NM0028  
Permit  
Mod.

**SUBJECT: LOS ALAMOS NATIONAL LABORATORY, NPDES PERMIT NO. NM0028355, NOTICE OF PLANNED CHANGE AT NPDES OUTFALL 051**

**Notice of Planned Change  
NPDES Permit No. NM0028355**

**Outfall 051  
Process Schematic Revision 11-14-2011**

PROCESS SCHEMATIC  
 NPDES OUTFALL 051

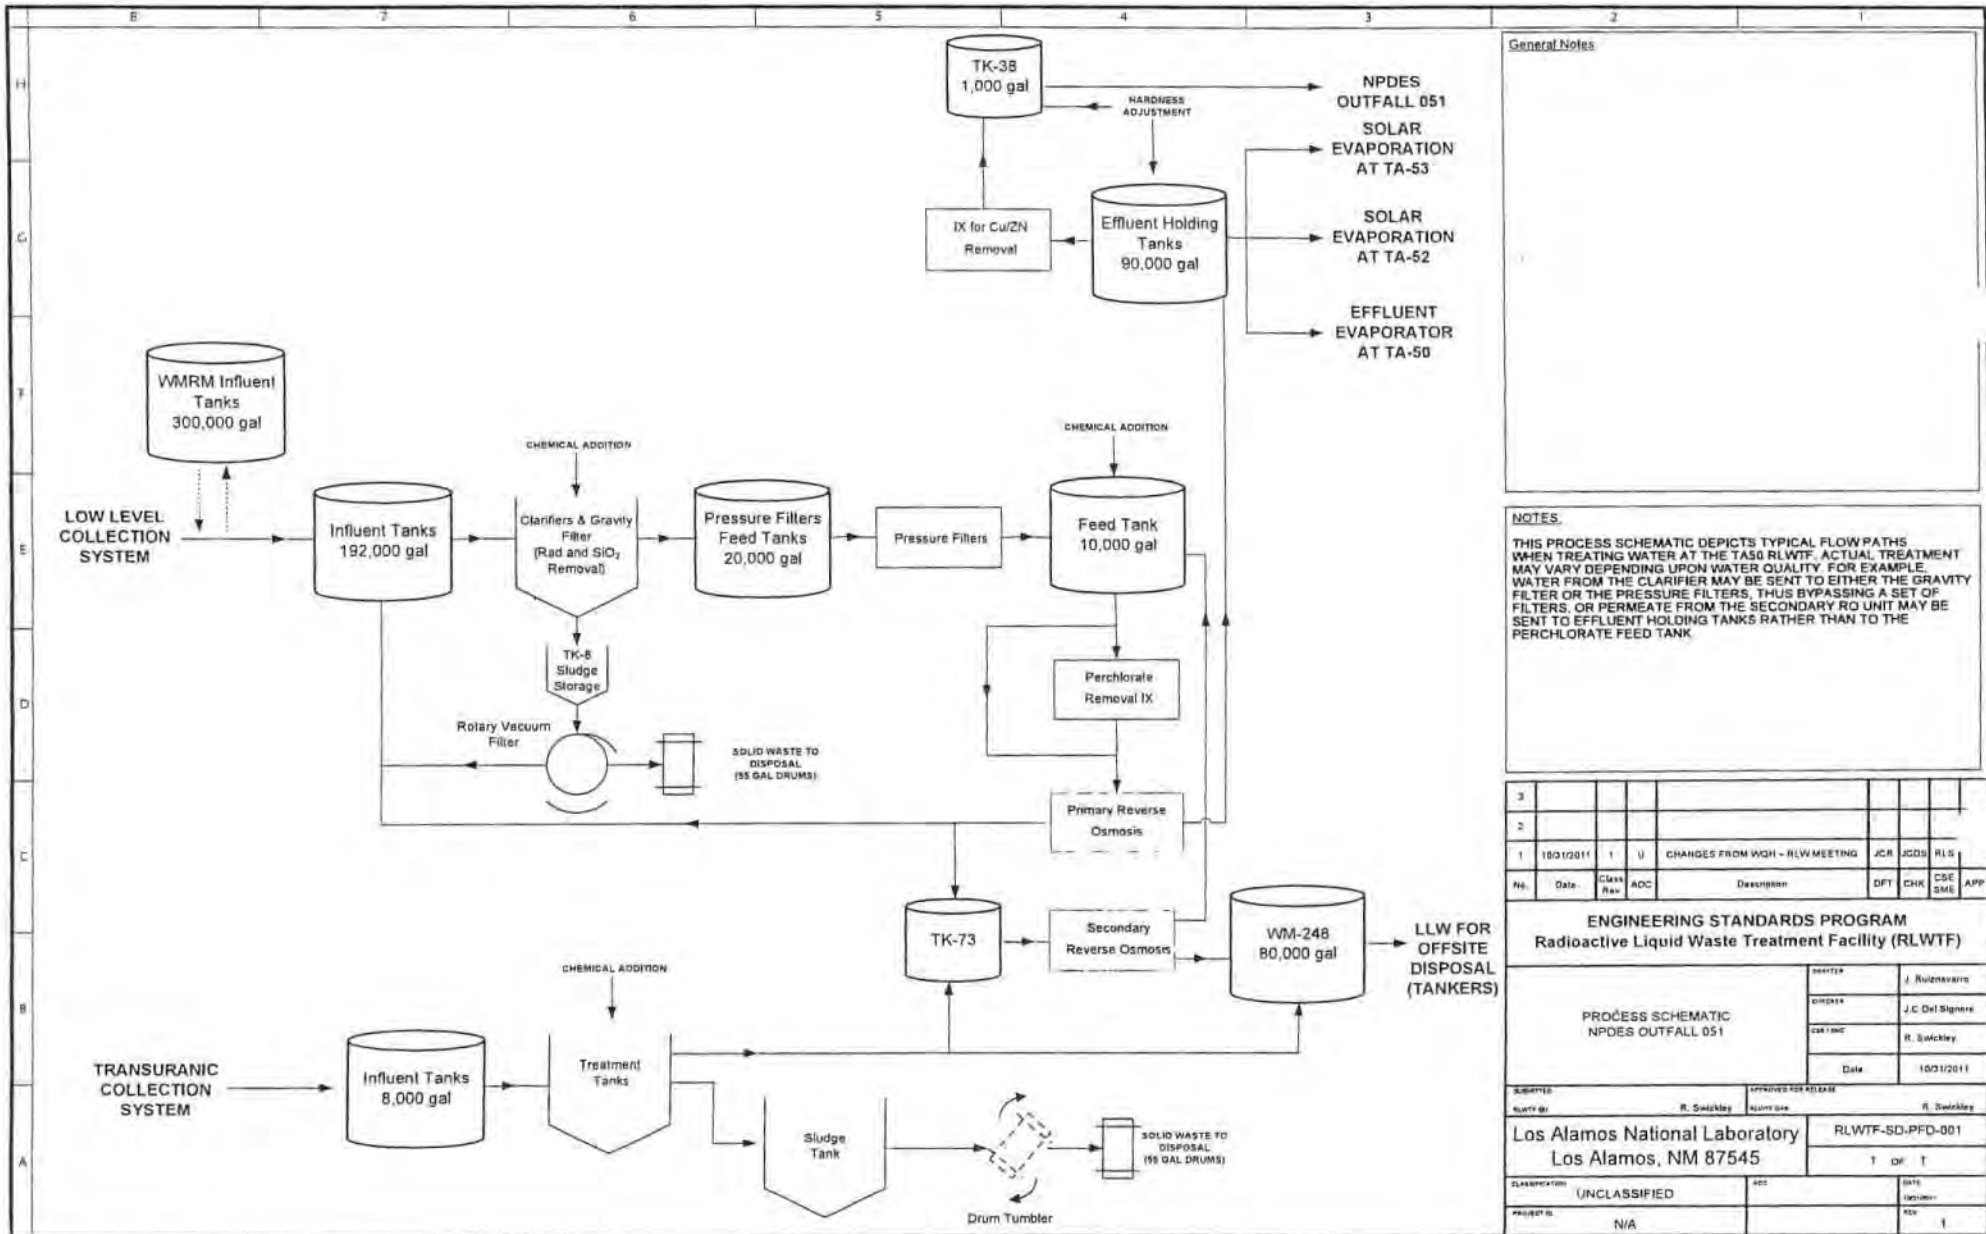
The purpose of this letter is to notify EPA of changes to the TA-50 Radioactive Liquid Waste Treatment Facility (RLWTF) process schematic previously submitted with the Notice of Planned Change, dated September 28, 2011 (reference ENV-RCRA-11-0204). The changes include re-naming the two reverse osmosis treatments to "Primary" Reverse Osmosis (formerly Reverse Osmosis) and "Secondary" Reverse Osmosis (formerly Sea Water RO), and the addition of comments explaining that treatments paths can differ depending upon water quality. This notification is being provided for clarification purposes only, even though neither of these name changes will change the nature of or increase the quantity of pollutants discharged at NPDES Outfall 051. Enclosed for your review is a revised schematic for the treatment of wastewater received at RLWTF (Enclosure 1). The revisions have been highlighted.
